222 & 240 Exhibition Street

# PLANNING REPORT

CoM Application Number	TPMR-2022-12
DTP Application Number	PA2201668
Address	222 and 240 Exhibition Street, Melbourne
Applicant Owner Architect	Lasalle Investment Management Pty Ltd c/- Urbis The Comedy Theatre Pty Ltd and The Trust Company Ltd Architectus
Proposal	Demolition (including partial demolition) of existing buildings and works; construction of buildings and works for a multi-storey, mixed-use building; and improvements to the rear of the Comedy Theatre
Cost of Works	\$211,866,000
Planning Controls	Capital City Zone (Schedule 1) Heritage Overlay (Schedule 632) Design and Development Overlay (Schedule 1) Design and Development Overlay (Schedule 10) Design and Development Overlay (Schedule 62-B4 & B6) Parking Overlay (Schedule 1)
Permit Requirements	<u>Capital City Zone</u> To construct a building or construct or carry out works (CCZ1) To demolish or remove a building or works (CCZ1) <u>Design and Development Overlay</u> To construct a building or construct or carry out works (DDO1, 10, 62)

Figure 21: Existing conditions to Lonsdale Street

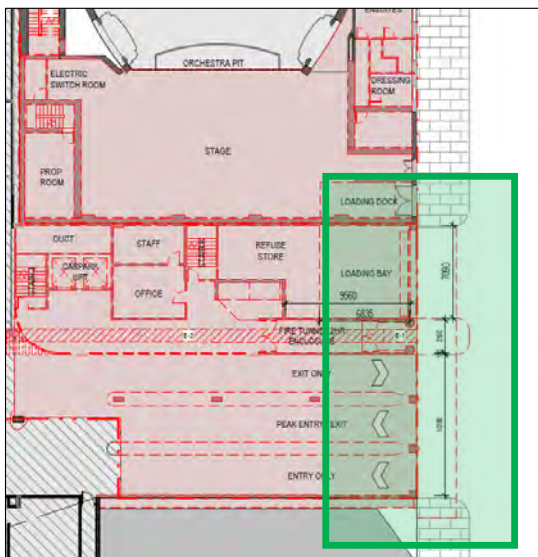
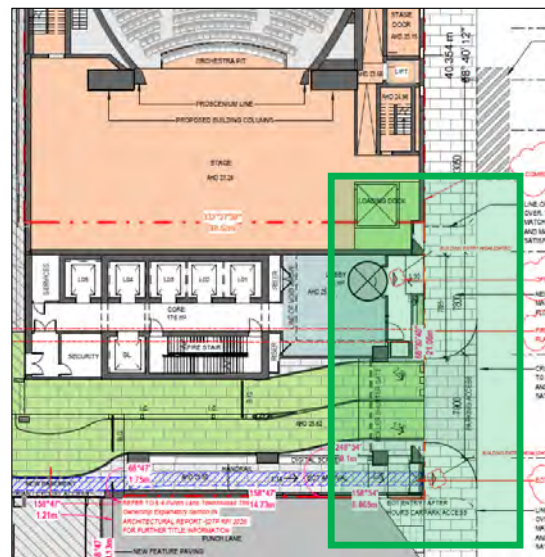
- o While the hotel lobby is elevated along Lonsdale Street, this is due to the car park entry which is an existing condition. The active hotel lobby will be at mezzanine level and therefore still a visible space from street level.
- o The office lobby is located directly off Lonsdale Street to assist in activating this street frontage and is an improvement on existing conditions.
- o The figures below demonstrate the improvement to Lonsdale Street from existing conditions.

Figure 25: Proposed Punch Lane hotel lobby arrangement

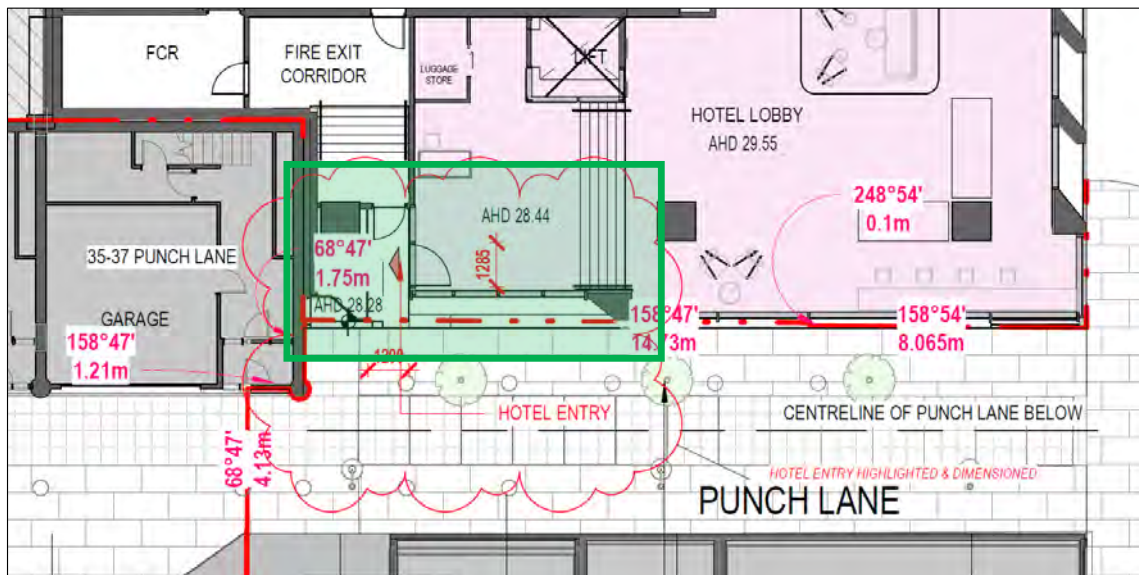
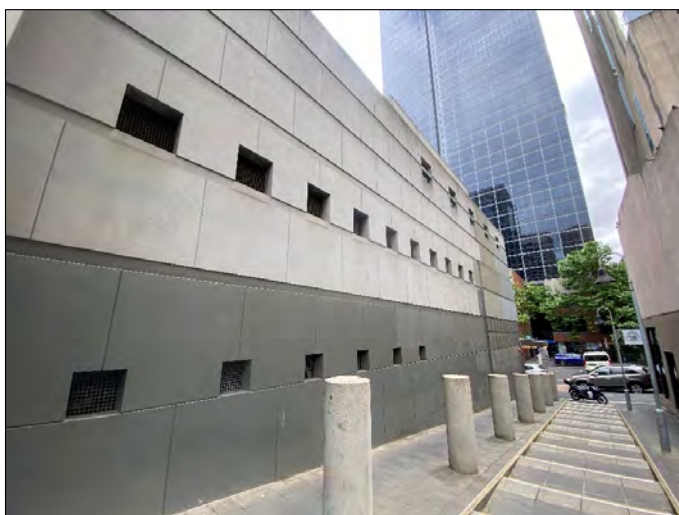
- Existing conditions are poor and the development provides an opportunity to create a high quality outcome along Punch Lane. By not providing a new entrance to the hotel lobby directly off Punch Lane, a significant shortcoming and missed opportunity has resulted. Instead, an illegible entrapment space is proposed (refer figures below). Having the ability to enter the hotel lobby directly off Punch Lane would significantly improve activation and interaction along this portion of the lane, which currently presents as two blank wall interfaces.

Further design improvements to the hotel lobby access along the Punch Lane interface is recommended to ease navigation and reinforce a sense of address and improve activation; and this should include relocating the entrance directly off Punch Lane, which in-turn would balance any shortcomings of the end-of-trip frontage as described above.

Changes to Punch Lane activation, entrances and artwork will form a recommendation to the Minister – refer Section 10.1 of this report.

Figure 29: Proposed digital screen within end-of-trip corridor

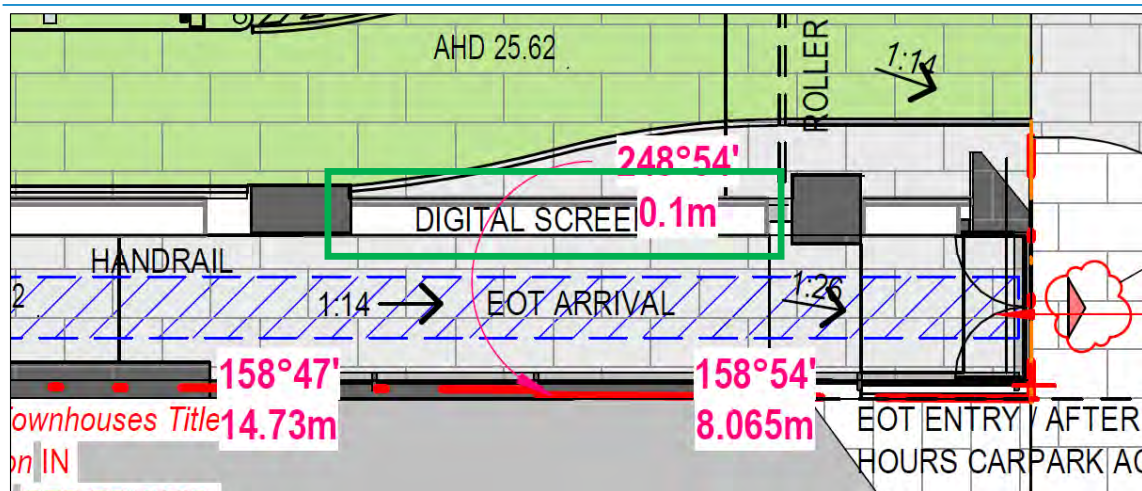
In relation to the digital screen, while the plans make reference to this, nothing formal has been applied for through the application. As this frontage will be highly visible due to the extent of glazing, any future application should take into consideration that in this location, a more appropriate design outcome could be the introduction of artwork in place of a screen. This would assist in avoiding potential promotional signage that may be dominant and unappealing. If a digital screen is accepted, details of this need to be provided and it should display artwork only unless otherwise applied for and fully considered.

Figure 30: Location of Theatre waste within 222 Exhibition Street (earlier iteration)

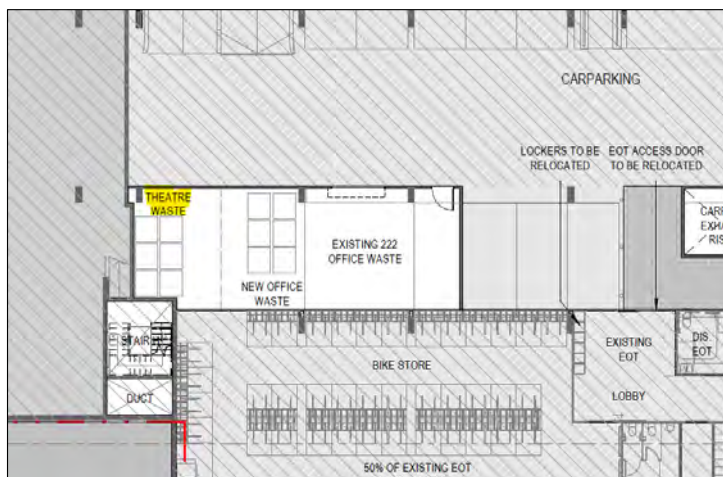
Subsequent versions of the WMP all made the same statements about existing waste storage at the Theatre not changing and showed car park waste storage areas with appropriate transfer routes from the Theatre.

Theatre is not shown on the proposed plans (240 Exhibition Street), waste management is considered an outstanding matter.

In summary, significant renovations to the Comedy Theatre are proposed and the applicant has a responsibility to provide accurate details about the proposed management of the significant weekly volume of waste being produced, as it has done several times previously. If the plan is to continue with the existing system, Council requests to understand what that is, as no waste storage is shown within the Theatre at 240 Exhibition Street.

Resolution of waste for the Comedy Theatre is an outstanding matter that must be resolved prior to a decision from the Minister for Planning – refer Section 10.1 of this report.

Figure 33: Proposed 5 m Lonsdale Street setback above the street wall (within DDO10)

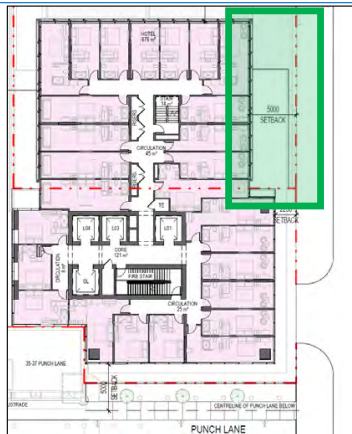
Above the street wall (Comedy Theatre), the proposed tower is set back 22.9 m from Exhibition Street and 5 m from Lonsdale Street, complying with the modified requirement and responding to the built form outcomes insofar as the setbacks respond to the context of the area.

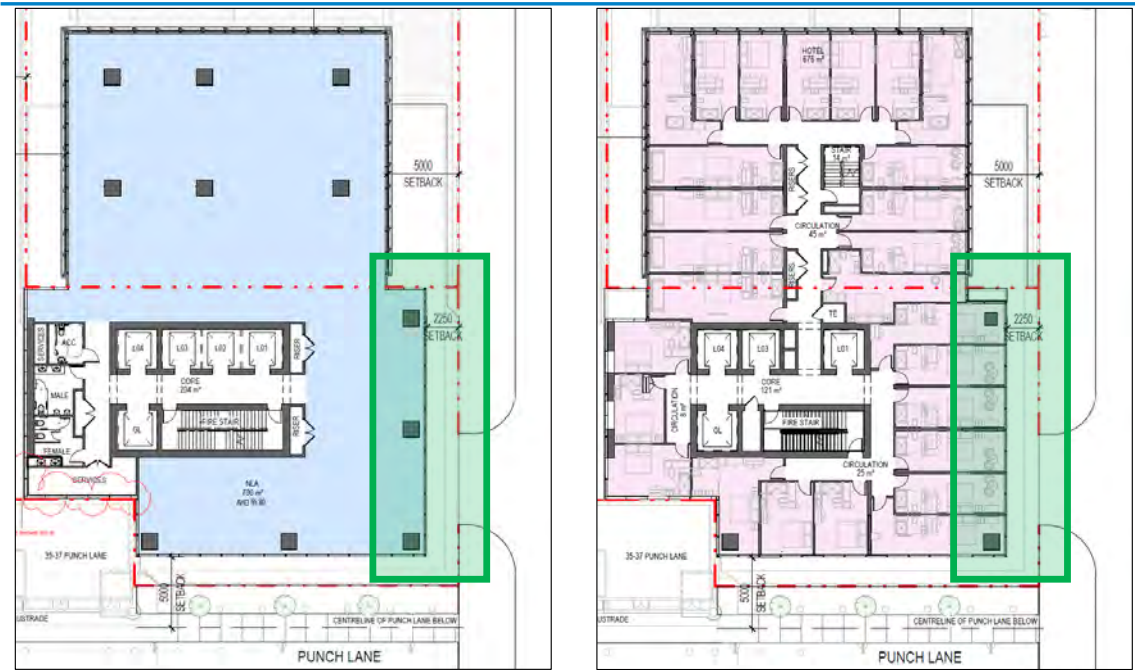
The proposed tower seeks to exceed the preferred height of 100 metres. On that basis, the upper-level setback to Lonsdale Street should exceed 5 metres to appropriately respond to the relevant built form outcome. However, the portion of the proposed tower affected by DDO62 provides a maximum setback of only 2.25 metres.

While it is acknowledged throughout this report that the prevailing context along this section of Lonsdale Street comprises tall buildings with minimal upper-level setbacks, the visual impact in this instance is not sufficiently alleviated.

Figure 43: Proposed zero setback at upper levels

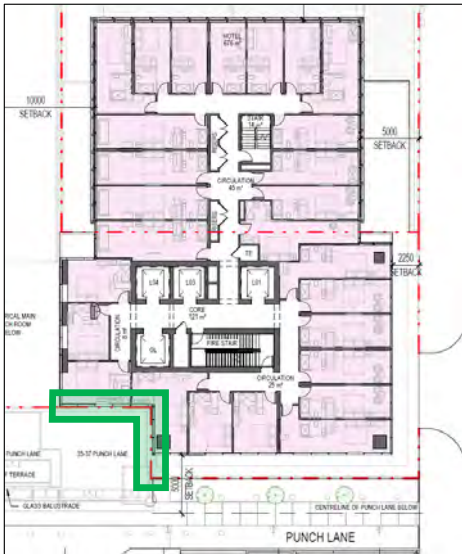
In some locations along the rear boundary, adjacent to the Punch Lane residential properties to the south, there is no setback for the full height of the tower (see image below). This represents a significant departure from the setback requirement and does not adequately address the Built Form Outcome, which calls for taller buildings transitioning down in height to adjacent areas that have a lower height limit, so as not to visually dominate or compromise the character of adjacent existing low-scale development areas.

Council officers recommend that this interface be reconsidered and that a setback from the Punch Lane properties (specifically 35–37 Punch Lane) be introduced. A 100-plus metre tower with zero setback directly behind three-storey townhouses would compromise the character of Punch Lane.

Figure 45: Proposed 3.075 metre setback from the centreline of Punch Lane to a height of 21 metres

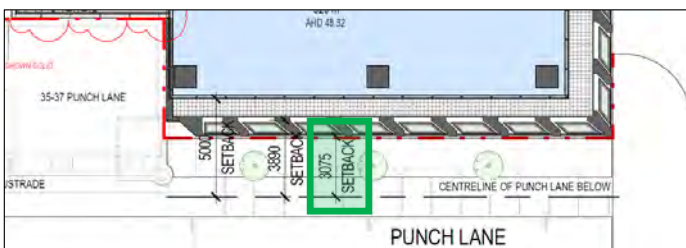
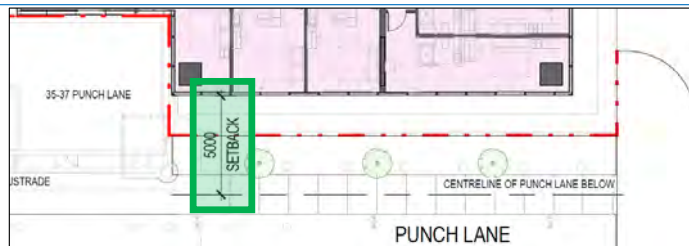
To the centreline of Punch Lane, the proposed tower is set back 3.075 metres up to a height of 21 metres, and 5 metres above 21 metres (see figures below).

Similar to the assessment above, Council officers recommend increasing the setbacks to the centreline of Punch Lane to ensure that the Built Form Outcomes are achieved. A prescriptive setback is not considered appropriate. Instead, the setback shortfall would be recorded as an outstanding matter to be resolved prior to a decision from the Minister for Planning – refer to Section 10.1 of this report.
